ALERT SERVICE BULLETIN

412CF-23-74

Revision A, 1 May 2024

SUBJECT: FLEXIBLE TUBING HCTE-1250-0 AND 130-056C10-0970, REMOVAL OF

Figure 1 (Sheet 1 of 7)

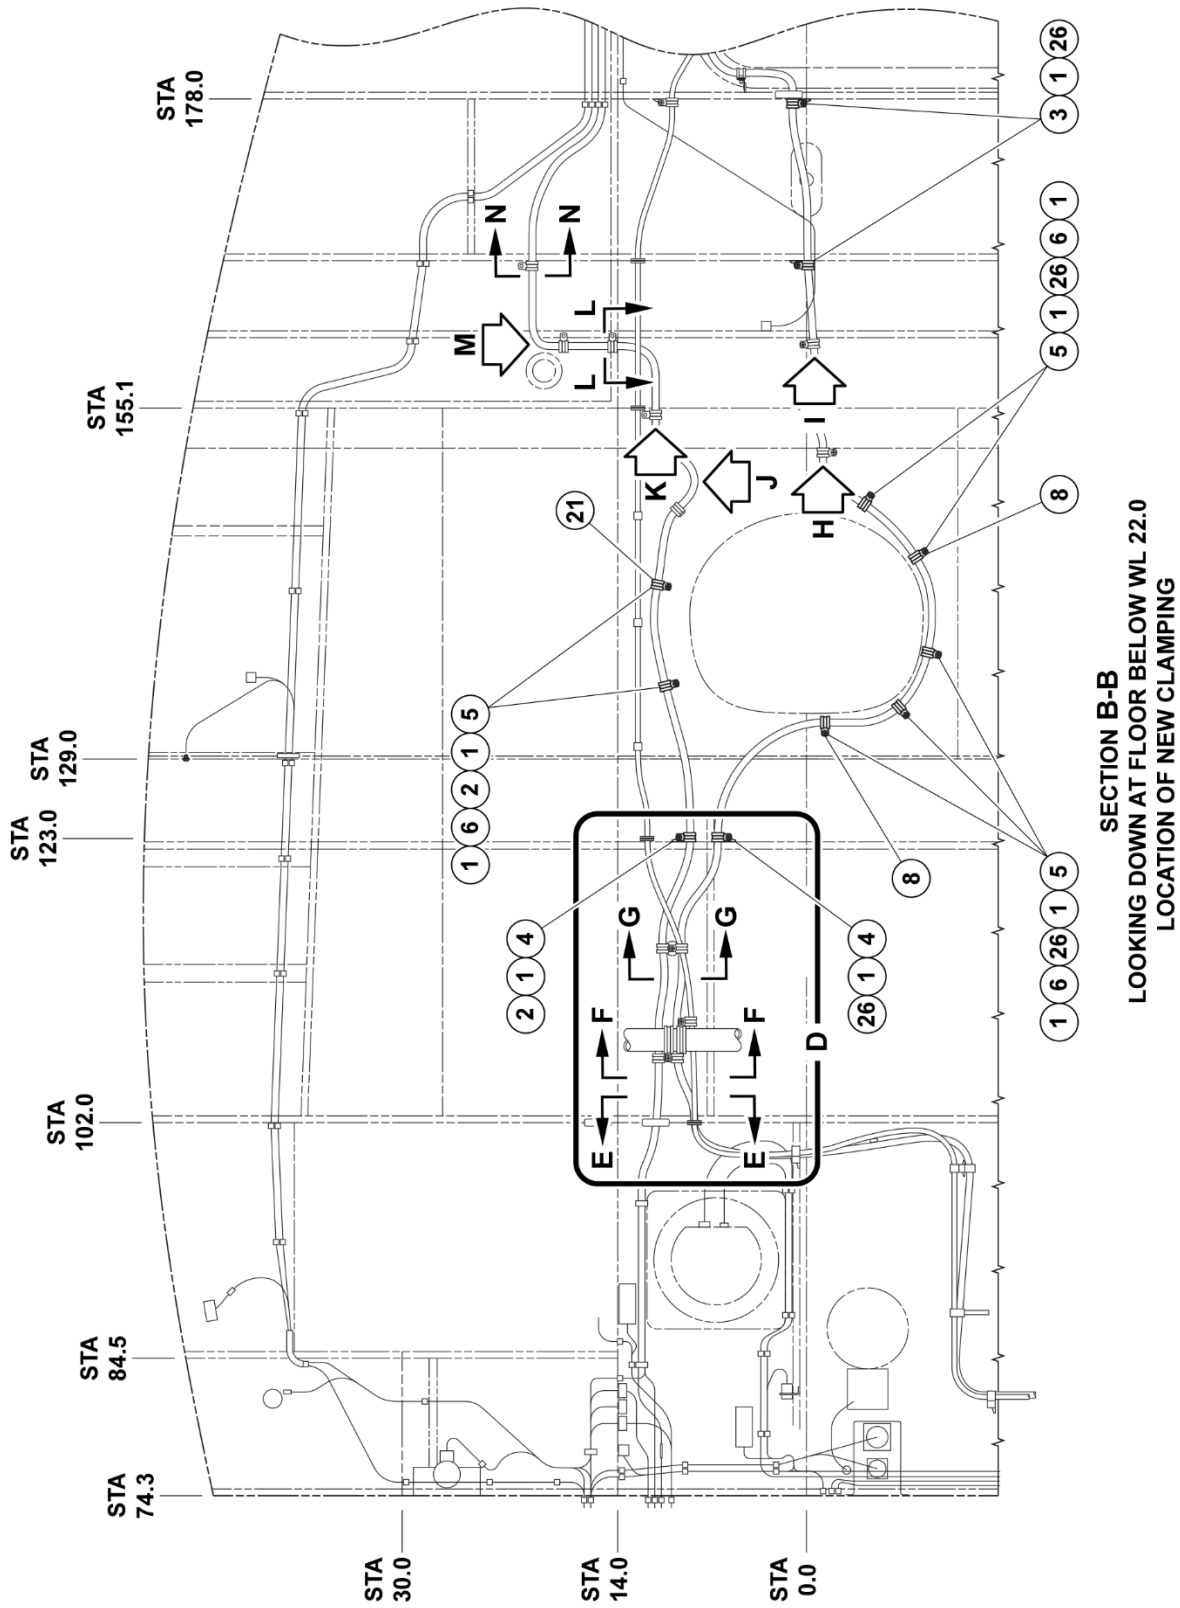
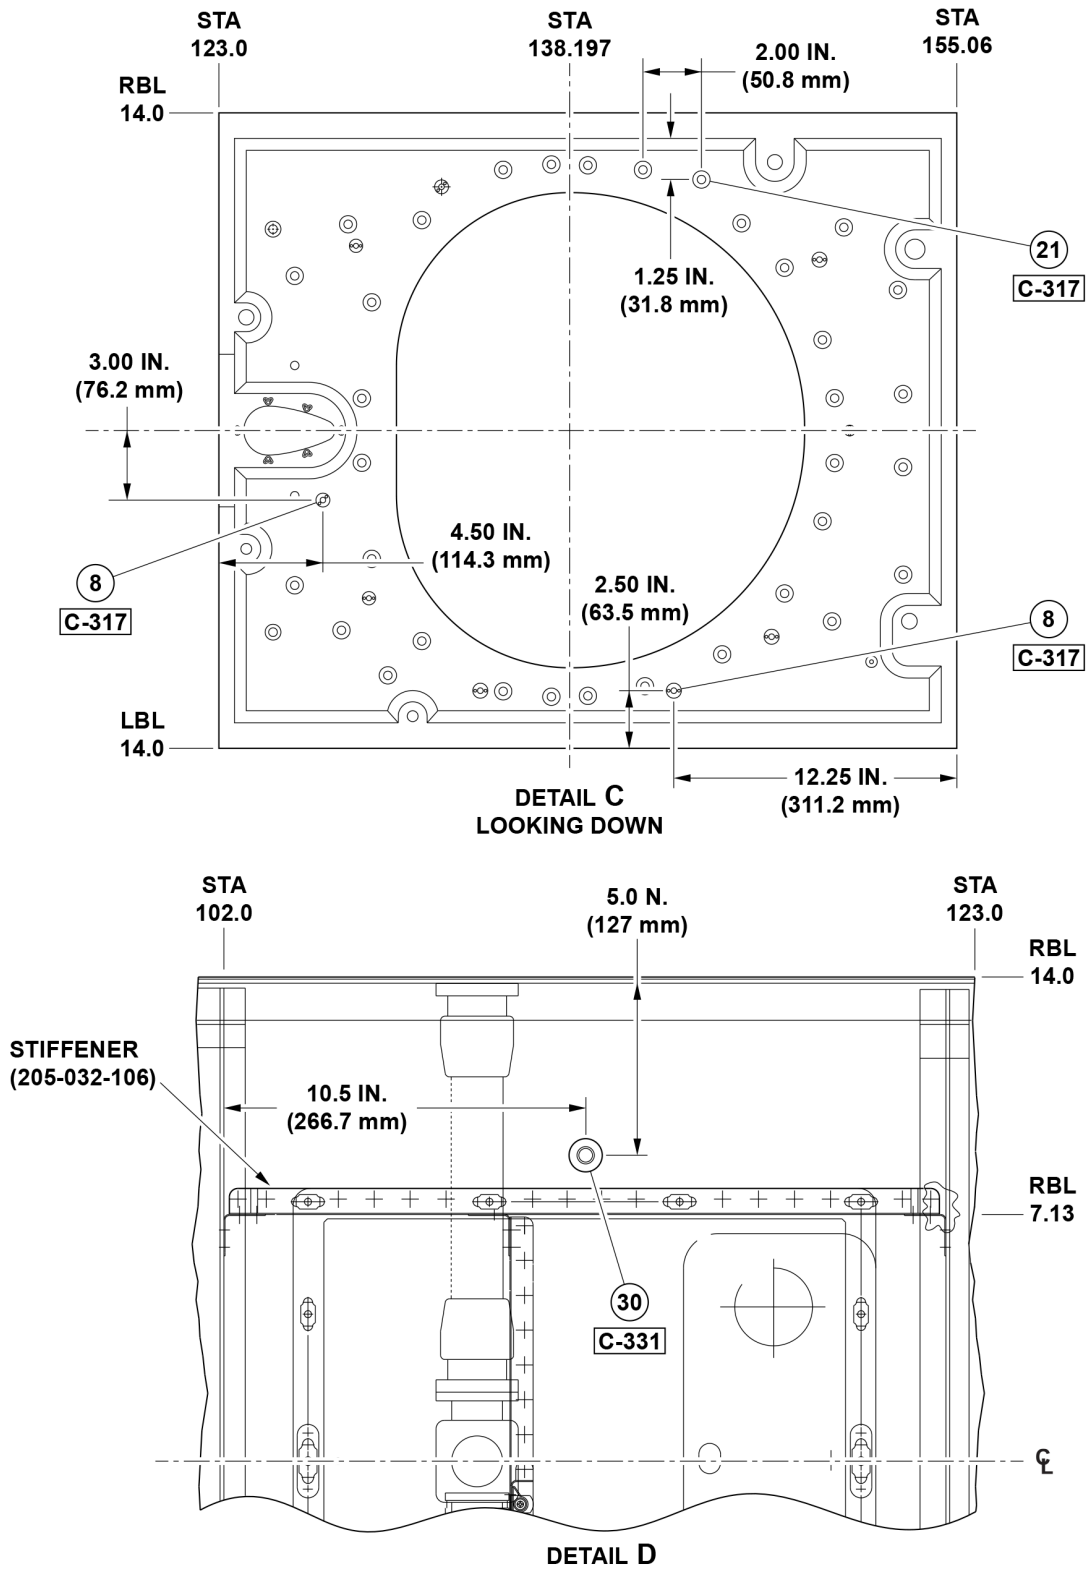
Revision A of this bulletin changes the location of insert (21, Figure 1, Section A-A, Detail C) slightly inboard and forward and changes the pictorial view of the panel to better represent the actual configuration.

1. Prepare the helicopter for maintenance.
2. Disconnect the helicopter battery.
3. Gain access to the flexible tubing (24, Figure 1 Section A-A).

4. Remove and discard, if applicable, clamping hardware that secures flexible tubing (24) to the aircraft structure.
5. Remove and discard flexible tubing (24) by cutting the tube lengthwise. Inspect for any damaged wires inside tube, remove and replace, or repair any damage wires.
6. Locate and install standoff (30, Figure 1, Section B-B, Detail D) using adhesive (C-331) as per the instructions in BHT-ALL-SRM Chapter 3.
7. Locate and install insert (21, Figure 1, Section A-A, Detail C) using adhesive (C-317) as per the instructions in BHT-ALL-SRM Chapter 3.

4. Remove and discard all clamping hardware that secures flexible tubing (25) to the aircraft structure.
5. Remove and discard flexible tubing (25) by cutting the tube lengthwise. Verify for any damaged wires inside tube, remove and replace any damage wires.
6. Locate and install qty 2 inserts (8, Figure 1, Section A-A, Detail C) using adhesive C-317 as per the instructions in BHT-ALL-SRM Chapter 3.

Figure 1 (Sheet 2 of 7)

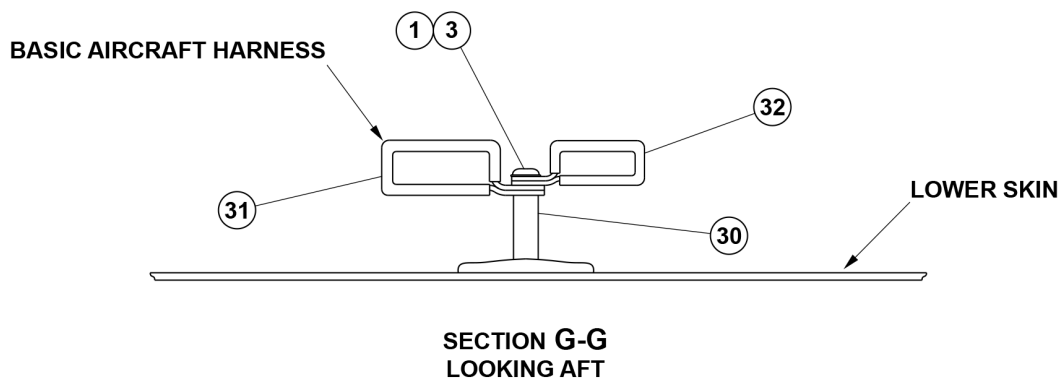
8. Secure wire harness to fuel line using screw (17, Figure 1, Section B-B, Section F-F) washer (1) clamp (16) spacer (6) clamp (31), washer (1) and nut (13).
9. Secure wiring harness using clamp (31, Figure 1, Section B-B, Section G-G) on previously installed standoff (30) using screw (3) and washer (1).
10. Secure wire harness on bulkhead STA 123.00 using screw (4, Figure 1, Section B-B), washer (1), and clamp (2).

11. Secure wire harness on existing insert, aft of STA 129.00 using screw (5, Figure 1, Section B-B) washer (1), clamp (2), spacer (6), and washer (1) between spacer (6) and the existing insert.

12. Secure wire harness on previously installed insert (21, Figure 1, Section B-B) using screw (5), washer (1), clamp (2), spacer (6) and washer (1), between spacer (6) and insert (21).

7. Secure wire harness to fuel line by adding clamp (32, Figure 1, Section B-B, Section F-F) to existing clamping arrangement using existing hardware.
8. Secure wire harness to existing standoff by adding clamp (32, Figure 1, Section B-B, Section G-G) using existing hardware.

9. Secure wire harness, at STA 123.00 using screw (4, Figure 1, Section B-B) washer (1) and clamp (26).
10. Secure wire harness on previously installed inserts (8, Figure 1, Section B-B) and on qty 3 existing inserts using screw (5), washer (1), clamp (26), spacer (6) and washer (1), between spacer (6) and inserts.

DETAIL K
LOOKING AFT AT STA 155.00

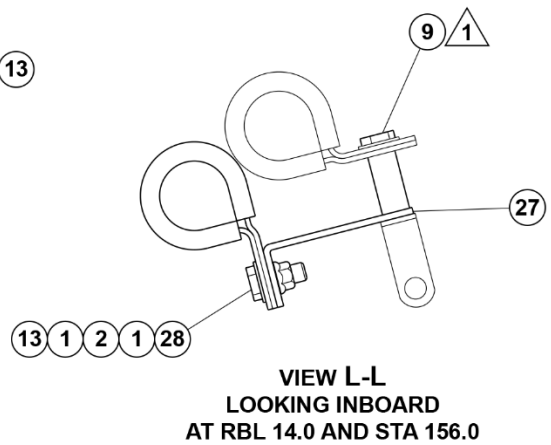
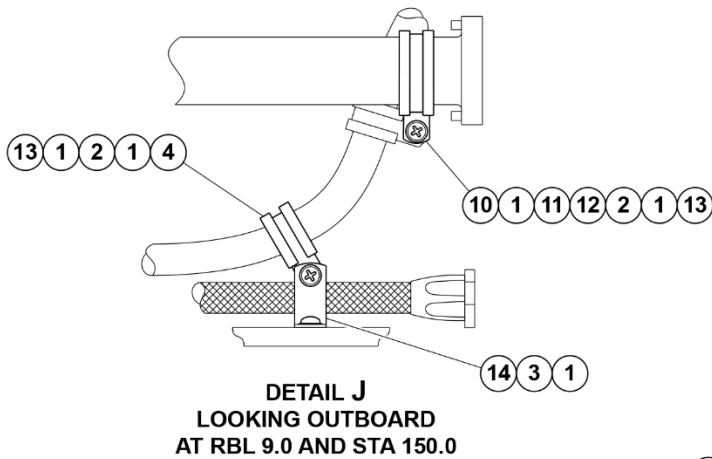
15. Secure wire harness on fuel line using screw (10), washer (1), clamp (11), spacer (12), clamp (2), washer (1) and nut (13).
16. Secure wire harness using screw (4, Figure 1, Section B-B, Detail K), washer (1), clamp (2), bracket (15), washer (1), nut (13), screw (4), and washer (1) on existing nut.

DETAIL H
 LOOKING AFT AT STA 155.10

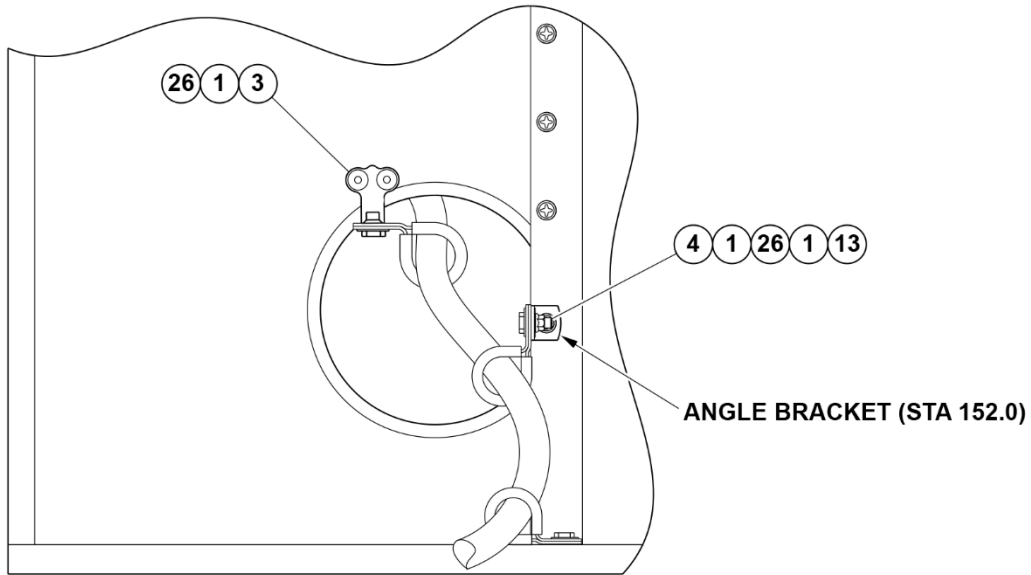
11. Secure wire harness on existing angle bracket on strut assembly forward of STA 155.10 using screw (4, Figure 1, Section B-B, Detail H) washer (1), clamp (26), washer (1) and nut (13).

DETAIL I
 LOOKING AFT AT STA 160.00

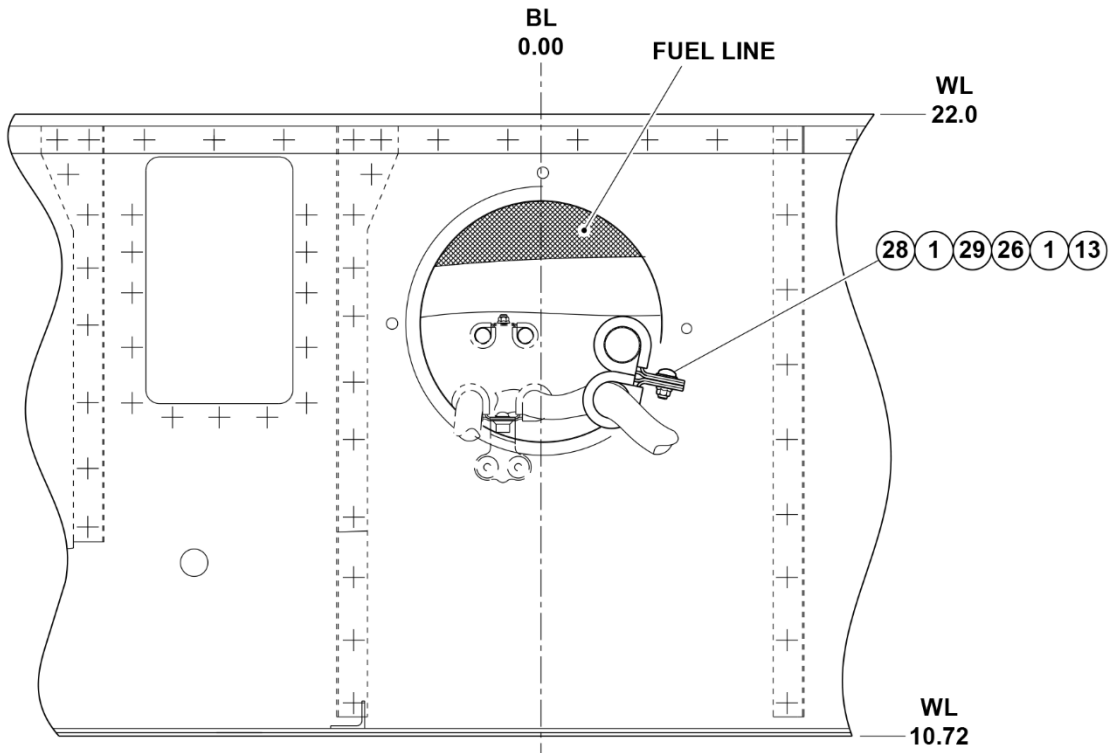
12. Secure wire harness on STA 155.10 using screw (3) washer (1) and clamp (26) on existing nut.
13. Secure wire harness on STA 160.00 using screw (28, Figure 1, Section B-B, Detail I) washer (1) clamp (29) on hydraulic line, clamp (26) on wire harness, washer (1) and nut (13).

DETAIL M
LOOKING INBOARD
AT RBL 18.5 AND STA 160.0

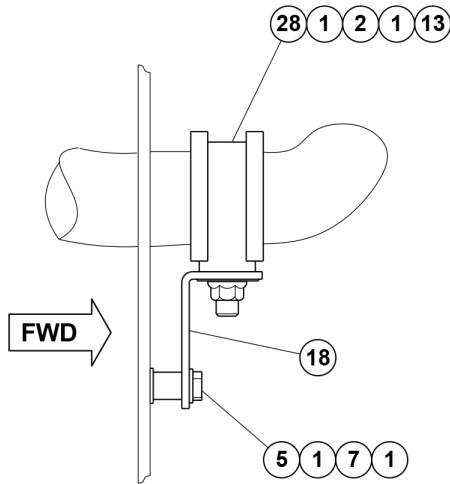
19. Install bracket (18, Figure 1, Section B-B, Detail M) on bulkhead STA 160.0 using screw (5), washer (1), spacer (7) and washer (1).
20. Secure wire harness on bulkhead STA 160.00 using screw (28) washer (1), clamp (2) on previously installed bracket (18), washer (1) and nut (13).

VIEW N-N
LOOKING AFT AT STA 166.5

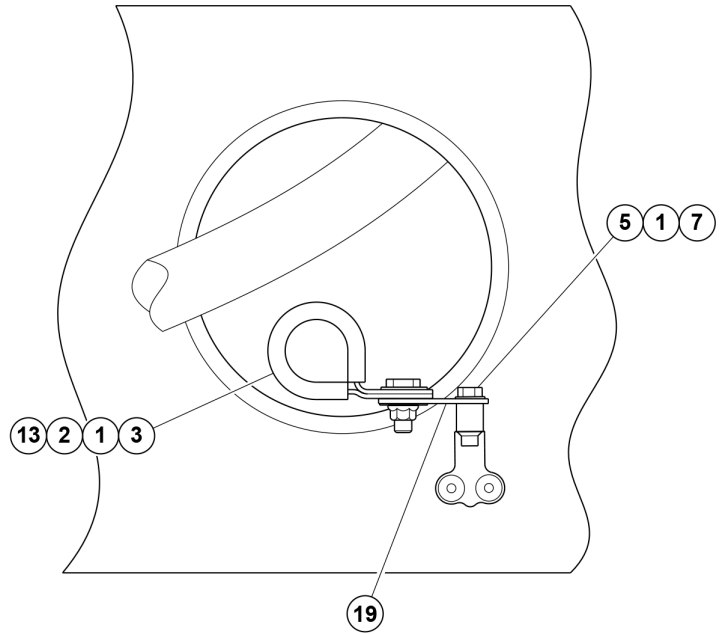
21. Install bracket (19, Figure 1, Section B-B, View N-N) on existing nut using screw (5), washer (1) and spacer (7).
22. Secure wire harness at STA 166.50 using screw (3), washer (1), clamp (2) and nut (13) on previously installed bracket (19).
